Ontario County Public Works

April 5, 2019

Re: Royal Car Wash
Route 332, Canandaigua

We have reviewed the plans for the above referenced project dated March 2019, sent by the Town of Canandaigua Development Office on March 18, 2019 and hereby submit the following preliminary comments:

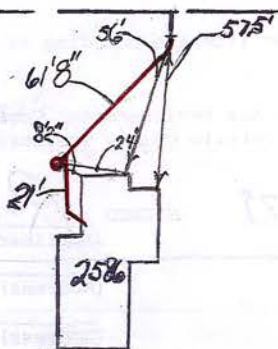
2. There is an existing 4" lateral servicing the property approximately 45' downstream of the manhole adjacent to the southeast property corner (a sketch from the maintenance staff is attached for your use). That lateral is required to be abandoned in the presence of District personnel. Depending on the location of the abandonment, an asbestos abatement may be required.

SANITARY SEWER MAIN & LATERAL TRENCH & BEDDING DETAIL

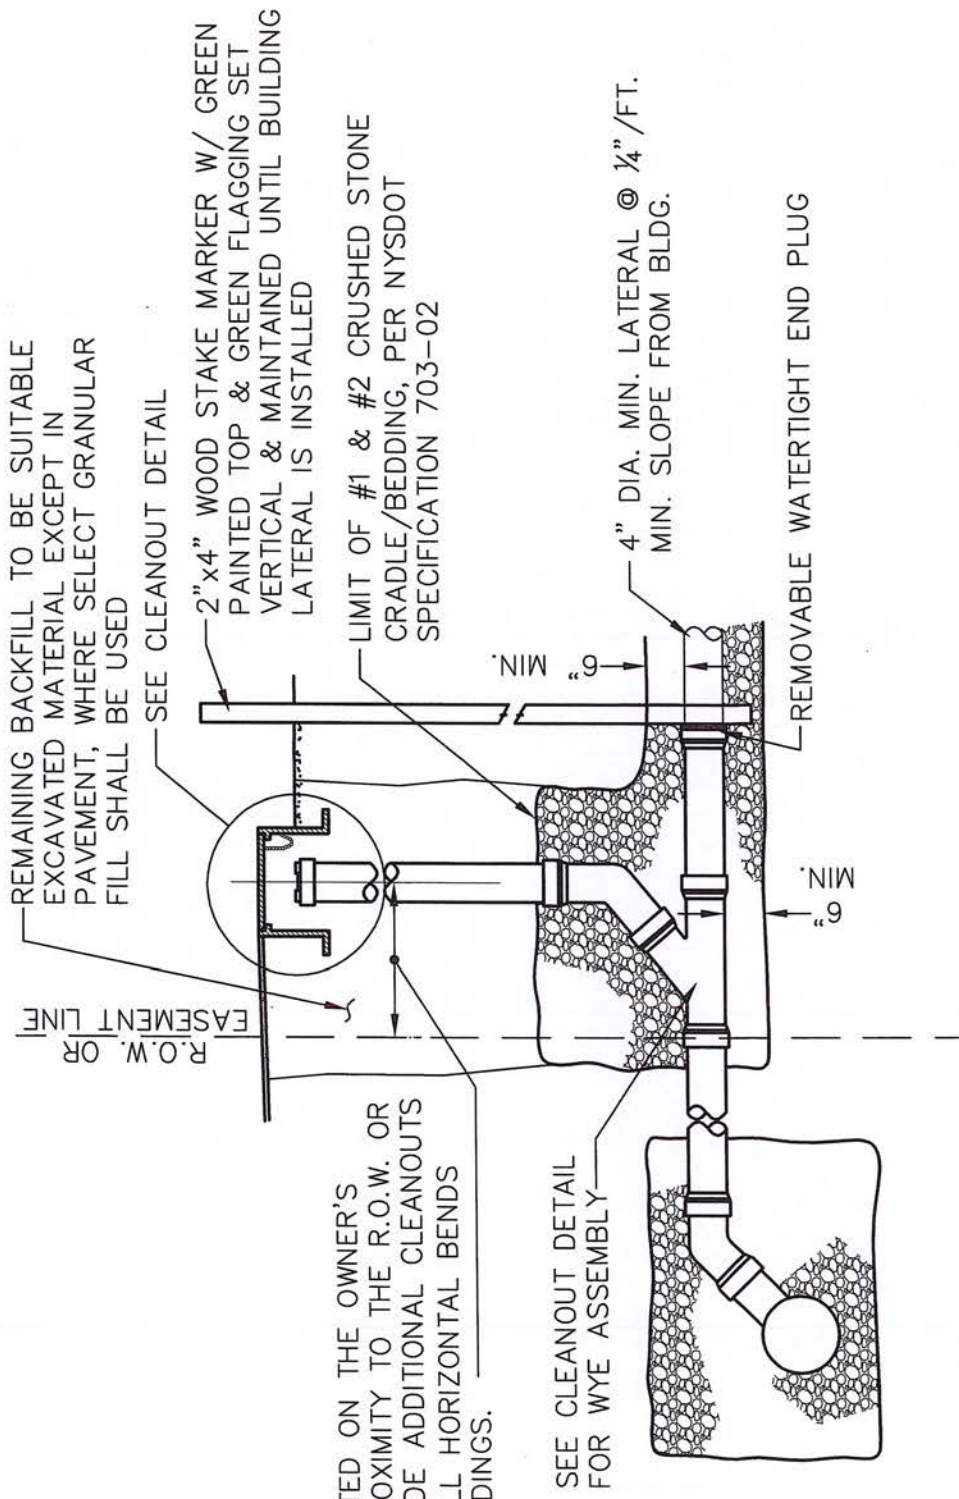
19. Remove "Sanitary Sewer" from the title of the Bedding Detail shown.
20. Add the attached Sanitary Sewer Main & Lateral Trench & Bedding Detail.
21. Replace the Sanitary Sewer Lateral Detail Privately-Owned Sewer Main detail with the Sanitary Sewer Lateral Detail provided.
22. Add the attached Sanitary Cleanout Detail.
23. Revise the Sewer Lateral Connection detail to indicate the correct sewer main material and show any adapters or special fittings required for a proper connection.
